MODIFICATION REQUEST:

61 Mobbs Lane, Epping (Former Channel 7 Site)

**Modification to the car park layout for
Buildings 7 and 8 (MP 10_0158 MOD 6)**

Director-General's
Environmental Assessment Report
Section 75W of the
Environmental Planning and Assessment Act 1979

Figure 3: Approved Building 8 Elevation (MOD 2)

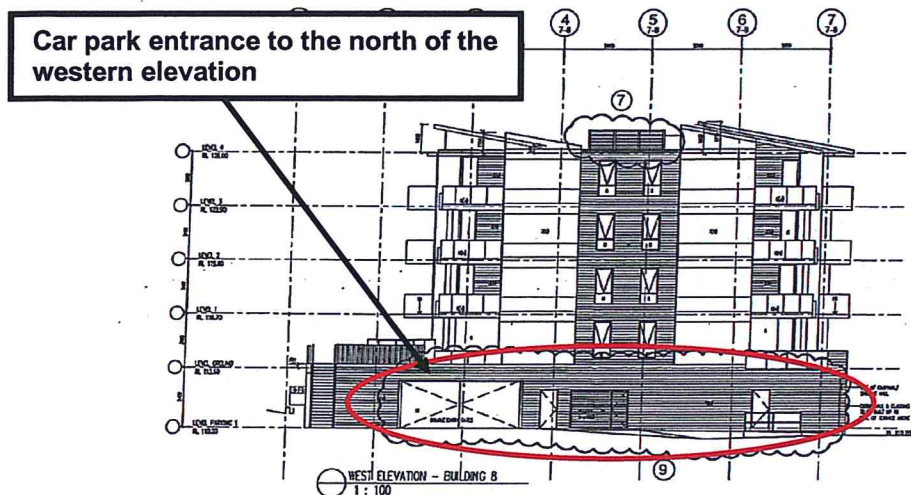
The approved plan indicates the car park entrance on the south of the western elevation for Building 8. As highlighted in section 2.1 **Figure 3**, the approved elevation of Building 8 shows the car park roller door to be located to the north of the western elevation for Building 8. The proposed entrance has been relocated to the north to allow for consistency with the approved elevation drawing.

Figure 5: Proposed Level 1 Lower and Upper Car Park

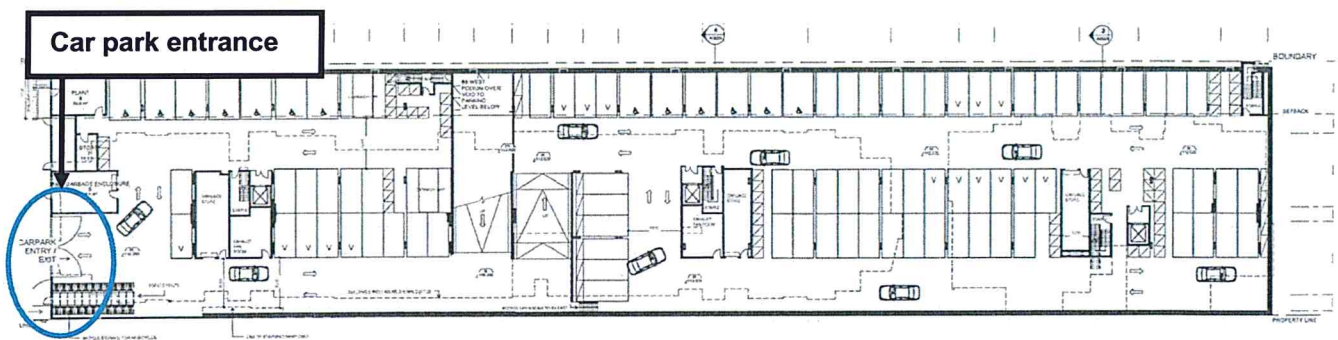
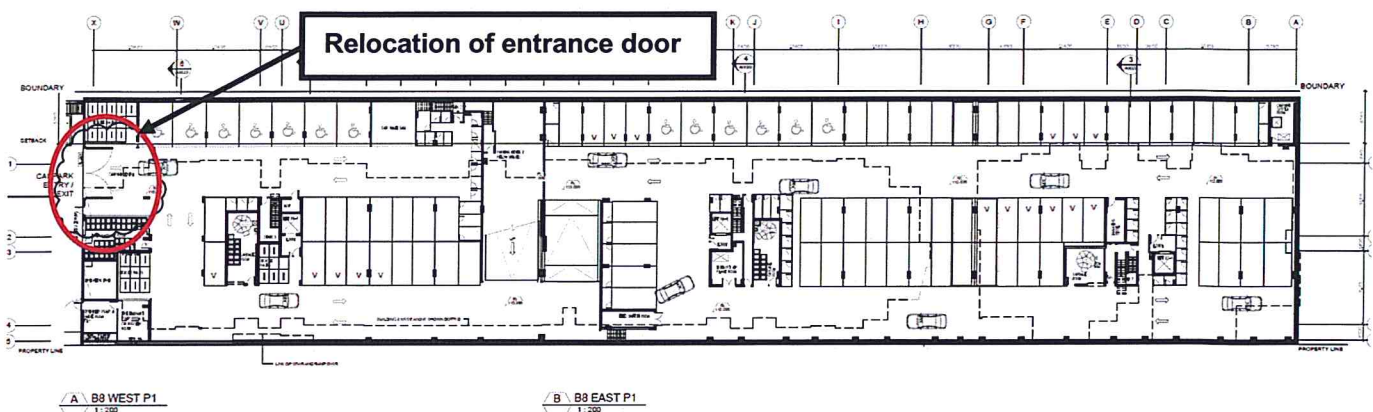
The proponent is seeking approval to relocate the car park entrance from the southern end of the western elevation of building 8 to the northern of the western elevation. The proposed modification is sought to provide consistency with the car park entrance depicted in the elevation approved under MP10_0158 MOD 2 (Figure 3).

The department considers the relocation of the car park entrance to the north to ensure consistency with the elevation drawing approved under MP10_0158 MOD 2 appropriate, and will not result in any adverse traffic impacts. In addition, the proposed car park entrance caters for the topography on site to improve construction. As a result of the proposed relocation of the car park entrance, minor internal reconfiguration of service rooms and bicycle storage spaces will be necessary. The department considers these changes are minor and will not reduce the functional aspect of the car park.

The department therefore, considers the proposed relocation of the car park entrance to the north of the western elevation acceptable.

It is therefore recommended that the amended car park plan A0011C be approved as outlined in the recommended Instrument of Modification Approval.
